**Environmental
Planning
Commission**

**Agenda Number: 2
Project Number: 1003859
Case #s: 11EPC-40067/40068
October 18, 2012**

Supplemental Staff Report

Agent	Tierra West LLC
Applicants	Silver Leaf Ventures LLC
Requests	<p>1 Site Development Plan for Subdivision Amendment (approx. 24 acres)</p> <p>2 Site Development Plan for Building Permit (approx. 11.5 acres)</p>
Legal Description	Tracts 1-6, North Andalucia at La Luz Tracts 1-3, North Andalucia at La Luz
Location	SE corner of Coors Blvd. NW and Montaña Rd.
Size	Approximately 60 acres
Zoning	SU-1 for C-2, O-1 Uses and PRD (20 dwelling units/acre)

OWNER'S ALBANY PROPERTIES NEW MEXICO	PROJECT NO. 45650	DATE 11/14	SHEET NO. 1
CONCEPTUAL OVERALL SITE PLAN		DATE 11/14	SHEET NO. 1
752 S. 24th Street, L.L.O. Albuquerque, NM 87110 www.albanyproperties.com		DATE 11/14	SHEET NO. 1
C3A		DATE 11/14	SHEET NO. 1

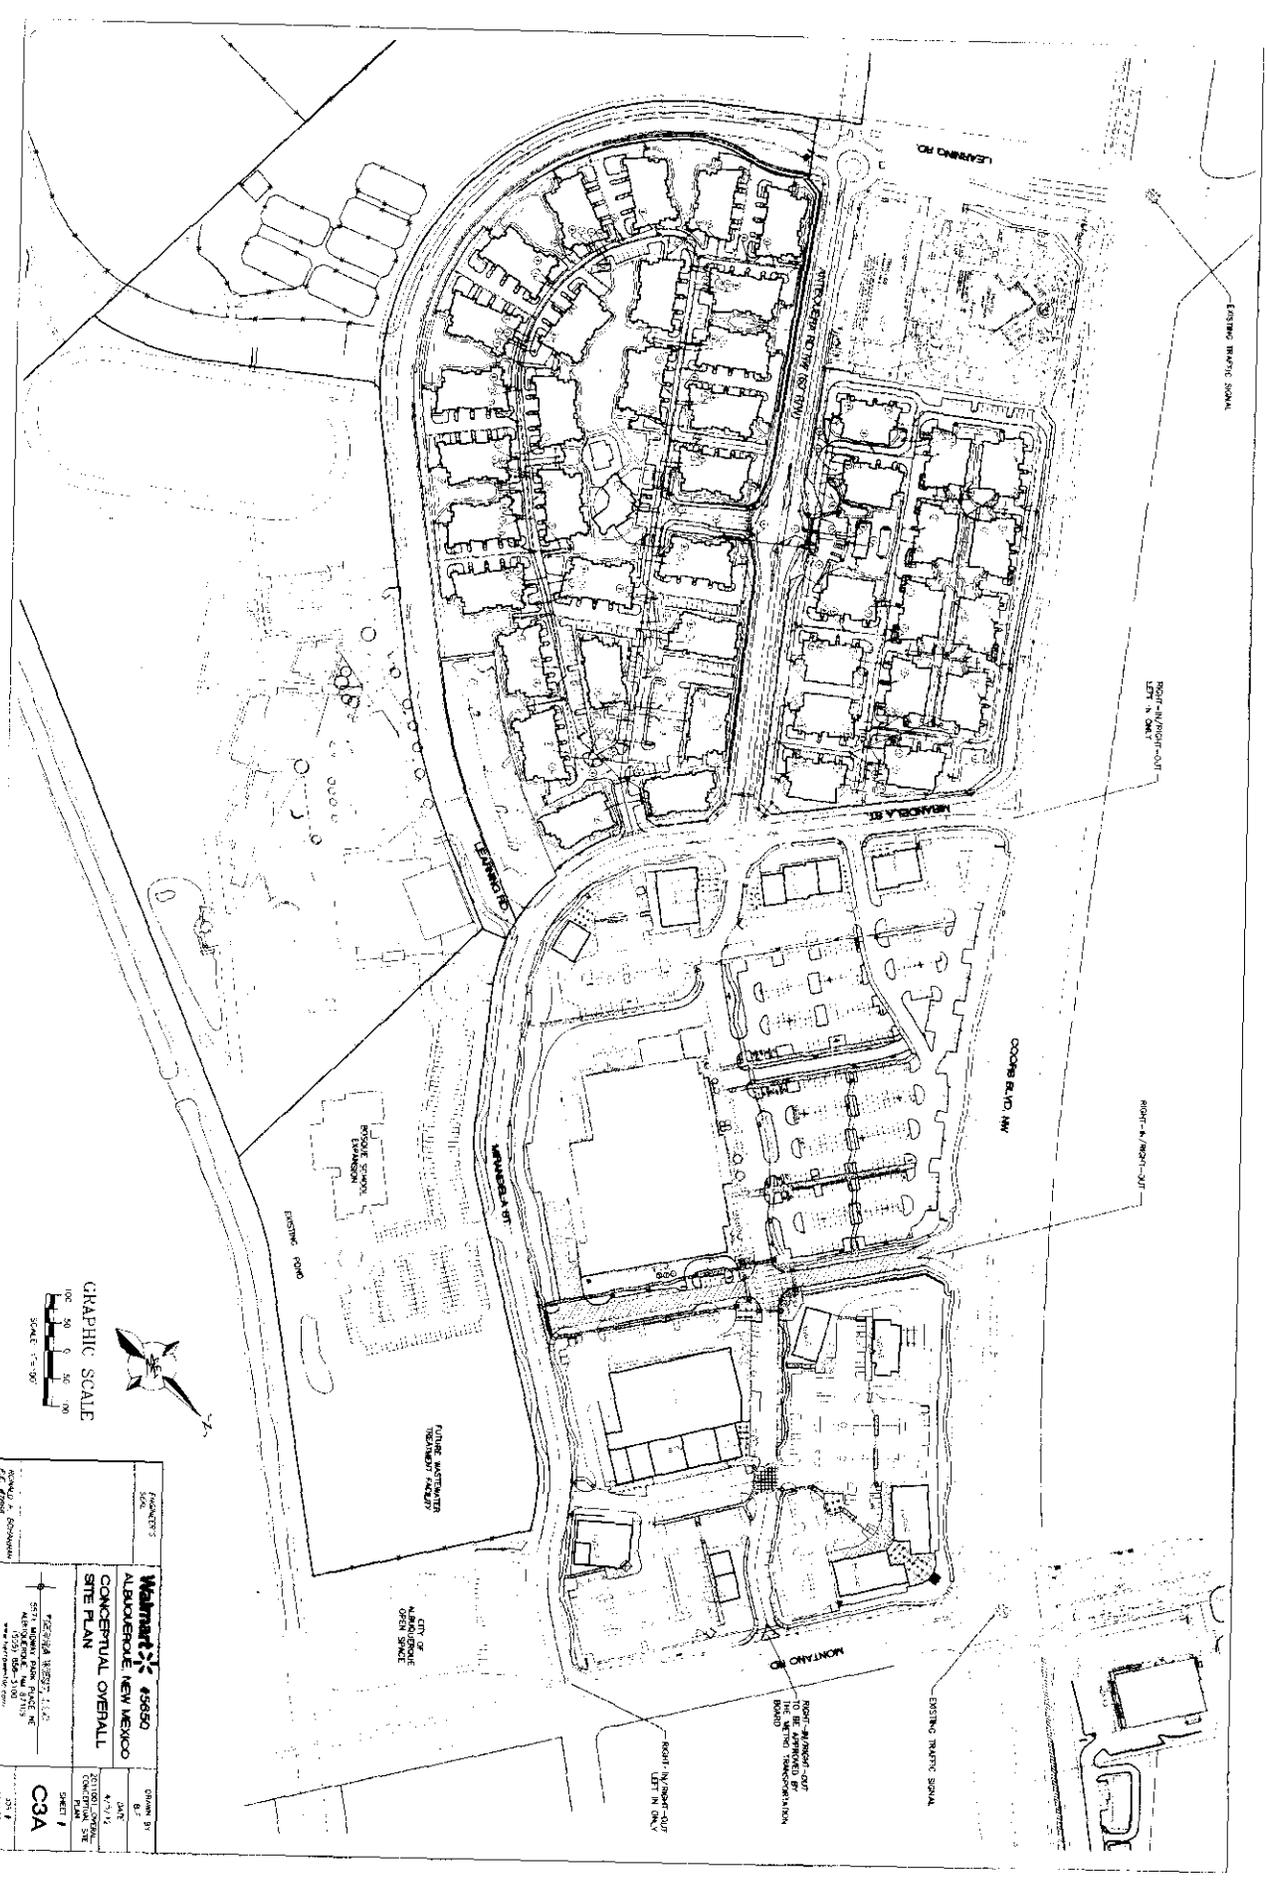
This sheet shows conceptual development of the entire, approx. 60 acre site, including the portion north of Mirandela St. (the subject proposal) and the portion south of Mirandela St. that has already been planned. Labeling is needed for clarification and it needs to be obvious what is existing, what is proposed and what is part of the subject proposal. The 300 ft. buffer line needs to be included.

<p>PROJECT # 196050</p> <p>ALBUQUERQUE, NEW MEXICO</p> <p>VIEW PLANE EXHIBIT</p> <p>DATE: 11/11/11</p> <p>BY: [Signature]</p> <p>SCALE: 1/8" = 1'-0"</p>	<p>DATE: 11/11/11</p> <p>BY: [Signature]</p> <p>SCALE: 1/8" = 1'-0"</p> <p>C6</p>
--	---

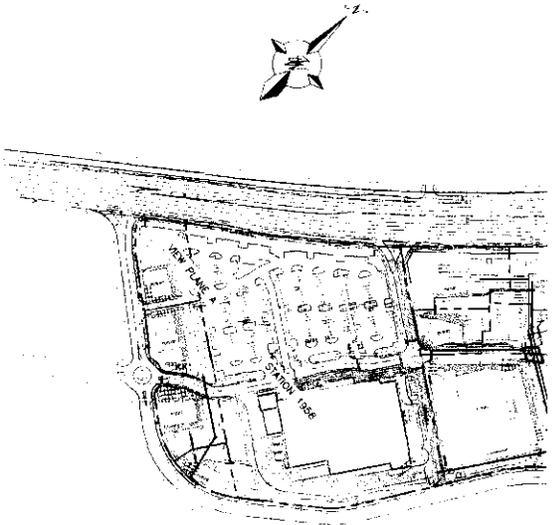
The applicant used a modeling program (Tremble Model VX Total Station) to show how the proposed building would appear in its context (Sheet C-6). The narrative explanation is insufficient; it does not discuss methodology enough to fully demonstrate compliance with the regulations. The data is not provided, so the elevations cannot be verified.

The January version showed four view lines (called "stations"). However, only one of the station view lines corresponded to a view line (View Line A) used in the view plane exhibit (see Sheet C-5 and analysis above). The other lines were not meaningful. One missed the building entirely. Another barely touched the building's NW corner, and the other intersected at the building's southern side. This was noted in the January Staff report. It is unknown why the applicant, at a minimum, did not produce a "station" line that corresponds to View Line B, and a new View Line C in the view plane exhibit, as requested in January.

included and therefore cannot be verified. The modeled building does not match the proposed elevations (see Sheet 16). For instance, the 33 foot tower on the northern side is not depicted. Furthermore, the image is so dark that the impact on its context is hard to assess. Also, the modeled building does not match the scale provided.

PARKING LOT LIGHT POLE
SCALE: 1/8" = 1'-0"

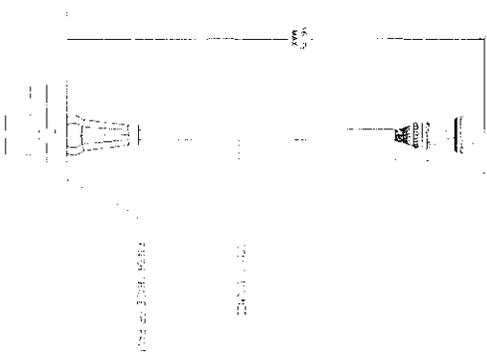
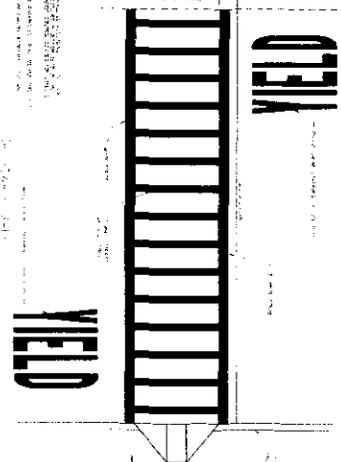
Two types of light poles are proposed (see Sheet C-13). Both are 16 feet tall. Parking lot light poles are proposed at various locations in the parking lot. Most have 4 fixtures per pole but some have 1 fixture (ex. near Coors Blvd.). Pedestrian light poles, with a single ornamental fixture each, are also proposed. The fixture type for each has changed since the January version. Instead of a "shoe box" fixture, the parking lot light pole fixture is more elongated. The pedestrian pole, which previously had two fixtures, now has a single fixture mounted on an ornamental detail. Both have ornamental bases.

The finish of the two proposed light pole types needs to be specified, since lighting must blend with the character of the building and other on-site fixtures. A note is needed on the lighting detail to state that cobra and high-pressure sodium lighting are prohibited. Notes regarding lighting should be moved from Sheet C-4 to Sheet C-13, and a detail of wall-mounted lighting provided.

SHEET 1
C16

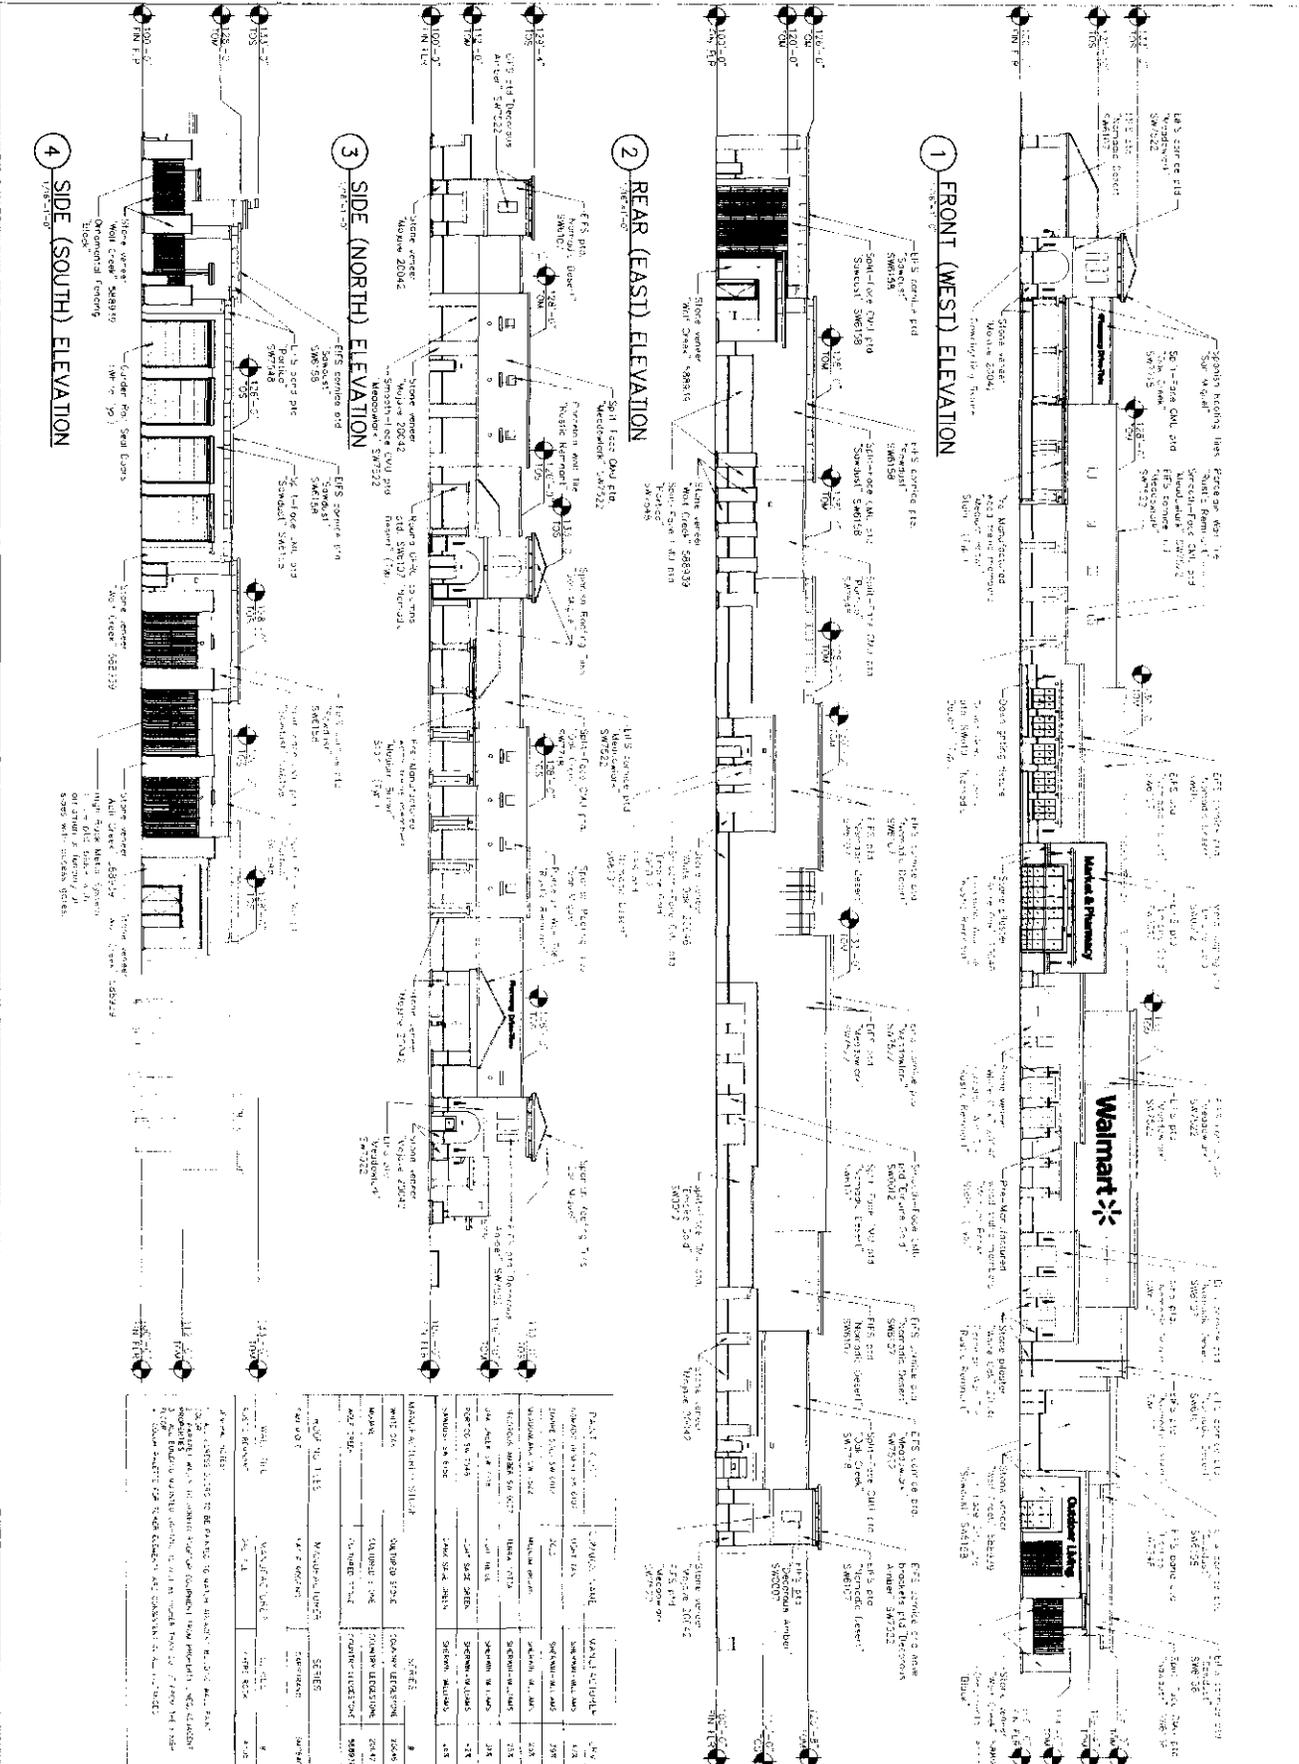
Wall-pack lighting, combined with pole lighting, is needed to provide on-site security. It appears that Wall-pack lighting is proposed on the west (main) elevation, labeled as "Downlighting fixtures", and on the north elevation. It appears that wall-pack lighting, a non-ornamental type, is proposed on the east and south elevations, but these are not labeled so they may be building features (Sheet C-16, Elevations). A note on Sheet C-16 indicates that wall-pack lighting would not be mounted higher than 20 feet.

Zoning Code §14-16-3-18(C)(3) requires that outdoor seating be provided for major facades greater than 100 feet long at the rate of 1 seat per 25 linear feet. The main façade is 437 feet long (see Sheet C-16). $437/25 \approx 17$ required seats. 16 seats are listed as required and the calculations are not shown. The site development plan states that 52 (was 24) seats are provided. 11 (was 6) benches are proposed, but it’s unclear how many seats are per bench (should be 4). If it’s 4, then 44 seats (not 52) would be provided. The keyed note and the detail need to be more specific. The benches need to be labeled on the entrance detail (Sheet C-8).

The length of the main (west) elevation has nine components (see Sheet C-16). From north to south, they are: drive-thru canopy, tower, "pharmacy drive-thru sign" façade, 80' façade with four tile ornaments, 92' market & pharmacy entrance façade, 86' main entrance façade, small stepped down façade, another small stepped down façade, and the outdoor living entrance façade. All vertical offsets measure at least 2 feet as required. The request complies.
